Docket Item #10
BAR CASE# 2004-0146

BAR Meeting
July 28, 2004

ISSUE: Addition and alterations

LOCATION: 326 North Patrick Street

Figure 1 West elevation

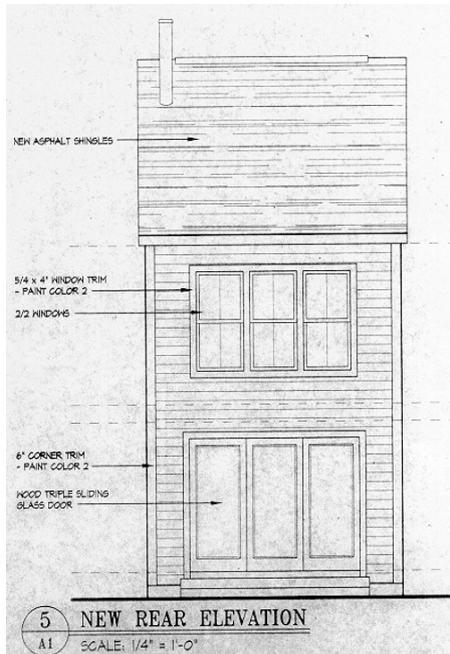
Regarding proposed new construction, Staff appreciates the use of the hyphen which minimizes the impact of the new construction on the historic main block by holding the larger section of the addition off from the main block. In addition, Staff appreciates the use of the flounder form for the hyphen. The form is a traditional form for additions in Alexandria and limits the impact of the new roof on the old.

On the other hand, Staff does not believe the larger addition section is as successful. Staff regrets that while the hyphen preserves some of the original rear wall of the main block, the larger addition section will totally block views to the back of the historic house. The use of mirroring gabled forms at front and back is unlike any traditional evolution of buildings in Alexandria. Staff believes that the proposed addition is so large that it overwhelms the historic house in terms of its mass and scale. It has a nearly identical footprint and is approximately 2.5' higher. An addition that is the same or larger size than the main block is contrary to traditional patterns of additions which were generally added in smaller segments and often narrower than the main block. While the old and new sections of the house can not be viewed together at the same time, and thus the relationship between the two parts will not be evident to the public, Staff still believes that the proposed addition fails to comply with the intent of the Design Guidelines which says that additions should be respectful of and not overwhelm the existing structure or neighboring buildings (Residential Additions - Page 5 & 6). Lastly, Staff notes that the 32' long and 21' to 27' high north elevation of the addition will present an oppressive wall to the neighbor to the north.

Staff recommends reducing the size and, if possible, the height of the rear addition section. A lower pitched gable or a flounder form would help to reduce the perceived mass of the addition.

Therefore, Staff recommends deferral for restudy to reduce the size of the rear section of the addition. On the other hand, should the Board approve the addition at this time, the following

Figure 3 North elevation

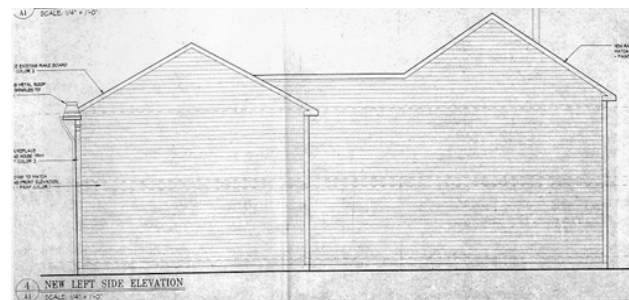
The following repair and replacement is proposed for the north side elevation:

- Replace existing rake board
- Repair/replace existing house trim

- New wood siding to match existing front elevation siding

Figure 4 East elevation

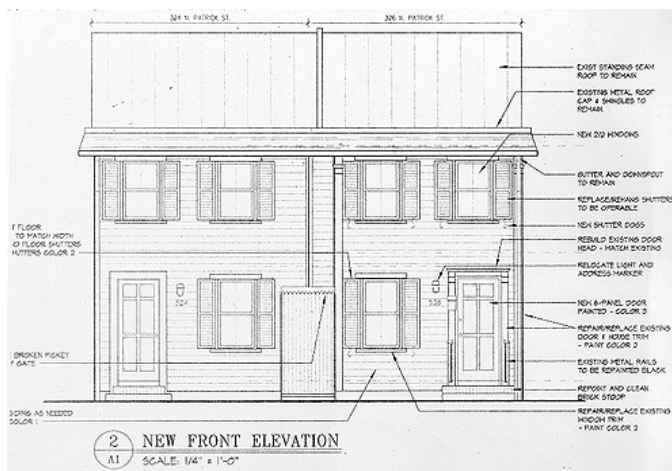
The following repair and replacement is proposed for the front (east) elevation:

- New two-over-two simulated divided light windows
- Replace or rehang second story wood shutters to be operable
- Rebuild existing door head to match existing
- Relocate light and address marker
- Replace door with new 6-panel wood door
- Repair/replace existing door and house trim
- Repoint and clean brick stoop
- Repair/replace existing window trim
- Repair siding as needed
- New first floor wood shutters to match width of second floor shutters

Staff has no major concerns about the proposed work for the existing historic building. As the existing six-over-one windows are in poor condition and are not likely to be original, Staff believes replacement is appropriate. While the Greek Revival detailing of the door surround and pilasters suggests that six-over-six windows, typical of the first half of the 19th century, might be more appropriate than two-over-two windows, typical of the last quarter of the 19th century, the precise construction date of the paired houses is unknown as is the precise date when two-over-two windows replaced six-over-six in popularity and common usage in Alexandria. Given that the house appears to date to this transitional period and the proposed two-over-two windows will match those in 324 North Patrick Street, the other half of the paired house, Staff believes they are acceptable. Staff believes the front windows should be true divided light windows rather than simulated divided light windows as they are readily accessible to the public and this is a mid-19th century building. Staff has no objection to the use of simulated divided light windows at the rear of the house as these will not be as visible and for the most part will be on new construction. The applicant might consider using one-over-one windows on the new construction to further distinguish new from old.

The proposed alterations to the shutters on the front elevation to make them operable and fit the

size of the windows will improve the historic appearance of the facade. The replacement of the current modern flat door with a paneled wood door is also an improvement. However, as with the windows, the appropriateness of the type of door proposed can be questioned. The six panel door is typical of the early and mid nineteenth century and by late nineteenth century had been replaced in popularity and usage by four panel door and a plethora of other decorative paneled and glazed combinations. Thus, if the replacement windows are to be the later 19th century two-over-two window type, it would seem that the door should also be a later 19th century type. However, as the proposed six-panel door will match the door at 324 North Patrick Street, Staff is willing to support it. The proposed replacement of the asbestos shingles on the north side of the historic house with wood siding to match that at the front will also approve the historic appearance of the house. Staff hopes that at some point in the future, the applicant will consider restoring the cornice. Staff notes that the plans call for general repair and replacement of the existing german siding and trim in a several areas. To the greatest extent possible the existing siding and trim should be retained, in particular the pilasters framing the corners of the house.

1. That the replacement windows in the front be true-divided-light windows; and
2. The following statement must appear in the General Notes of the site plan so that on-site contractors are aware of the requirement.
Call Alexandria Archaeology immediately (703-838-4399) if any buried structural remains (wall foundations, wells, privies, cisterns, etc.) or concentrations of artifacts are discovered during development. Work must cease in the area of the discovery until a City archaeologist comes to the site and records the finds.
